# 6th Edition (2017) Update to the Florida Building Code

## Proposed Code Modifications

## Fire

### Proposed Code Modifications

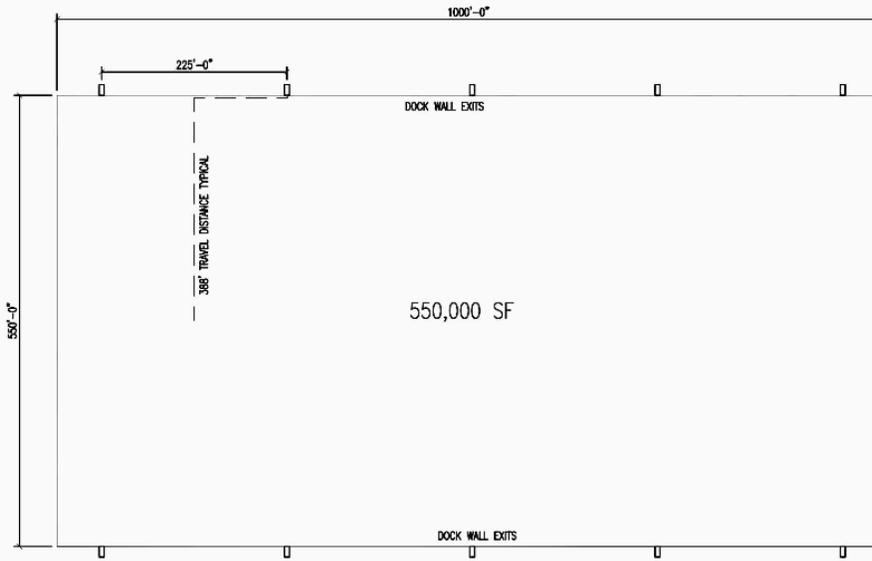
The actual "hard" cost of current S-1 limited 250' travel distance code compliance would need to be evaluated on a building/project specific basis, based on the unique physical characteristics for each one. A general statement of negative cost impact with the current code is that construction costs increase with the current travel distance because the building's wall-to-floor area ratio increases in order to capture the desired square footage; a square building is most efficient, and the wall-to-floor area ratio, and cost, increases as the building aspect ratio increases. Simply put, long skinny buildings are a lot more expensive to build than square/deeper ones for the same square footage. Operational costs for shallow depth/long buildings are addressed below.

Land owners that have planned for large distribution centers are finding that businesses can no longer build the size and depth of buildings for S-1 Storage that have been allowed before the 2014 code change. Many of such parcels are not easily converted to other uses as the large DC sites do not generally share property lines with smaller depth sites for non-related uses.

EXAMPLE A  
FBC 2010 (PROPOSED FOR 2017) - 400' TRAVEL DISTANCE FOR S-1 SPRINKLERED

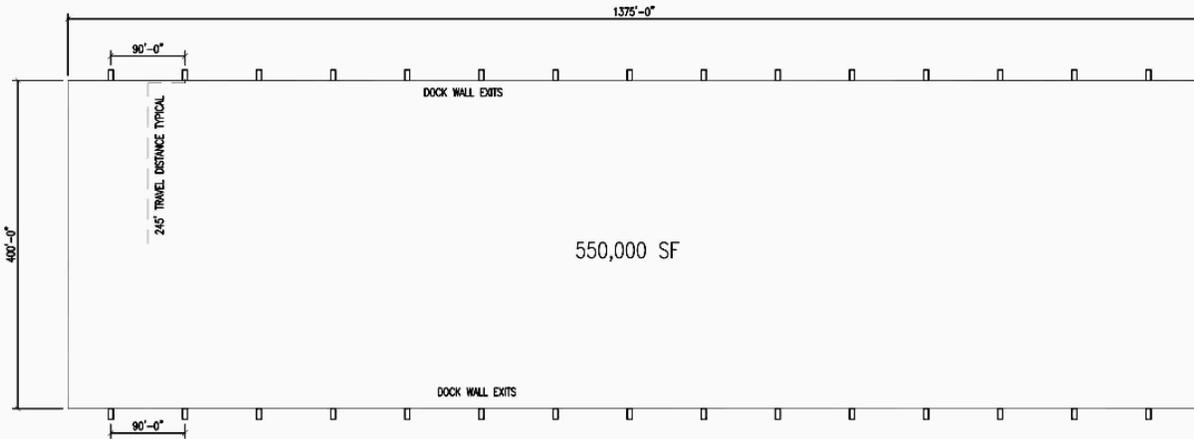
Going back to 400' allowed travel distance for S-1 in sprinkled buildings will allow for a relative reduction in construction costs due to greater building efficiency.

We are currently seeing the code restrict the layout of large Distribution Centers that can no longer be built for operational efficiency. The trend for several decades in the U.S. has been to create very large distribution centers (i.e. 250,000 GSF - 1M+ SF). Most of the existing Distribution Centers would not be allowed today due to the travel distance restriction of 250' max. Some businesses can not expand their current facilities as planned for previously under the current code and maintain building continuity.

The bigger picture is that we are seeing people re-consider putting their large Distribution Centers (DC's) in Florida. Most are confounded when we explain and/or show them the code restricting their travel distances to 250'. Many of the DC's are deep buildings (450'-600' +/-) with loading doors on each side, with large staging/unloading areas adjacent to the doors with the bulk and/or high piled storage in between. By seriously limiting the building depth, the logistical operations are severely compromised, or not practical at all.

Allowing 400' allowed travel distance for S-1 in sprinkled buildings will allow companies with large Distribution Center, needs to operate more efficiently.
